Product Change Notification / LIAL-02XWMF227

CCB 5129 Final Notice: Qualification of G700 as a new molding compound material and NiPdAuAg with roughened as a new lead frame DAP surface prep for selected MIC7300, MIC2778, MIC833, and MIC2779 device families available in 5L SOT23 package assembled at STAR assembly site.

Pre and Post Change Summary

PCN #: LIAL-02XWMF227

Lead Frame Comparison

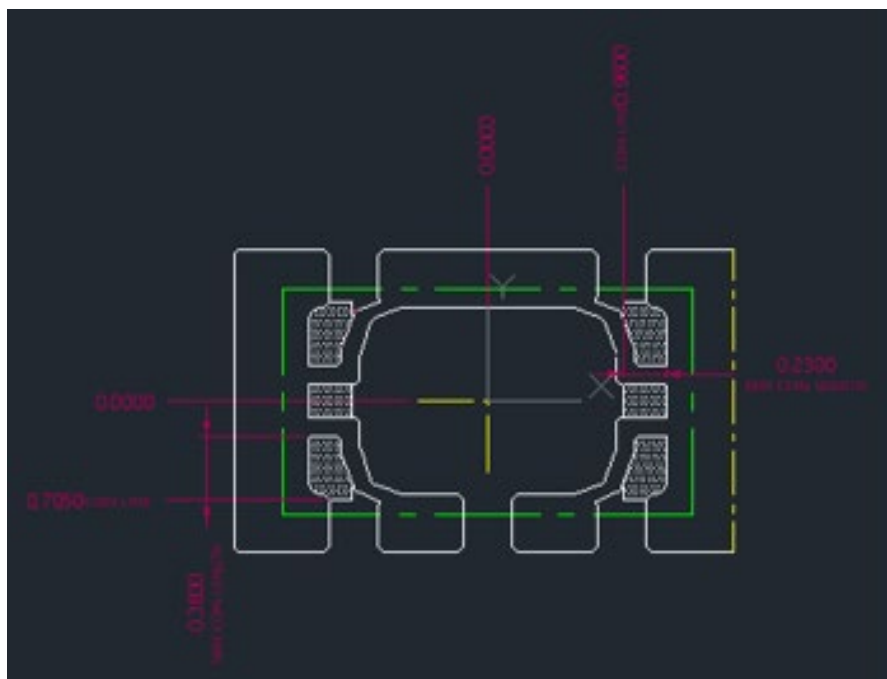
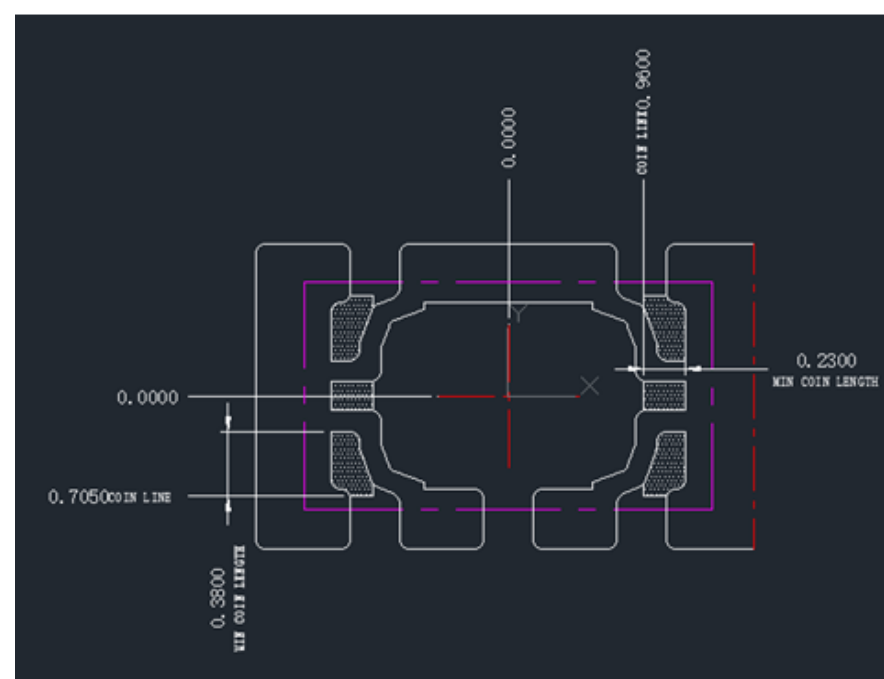
Description of Change:Qualification of G700 as a new molding compound material and NiPdAuAg with roughened as a new lead frame DAP surface prep for selected MIC7300, MIC2778, MIC833, and MIC2779 device families available in 5L SOT23 package assembled at STAR assembly site.
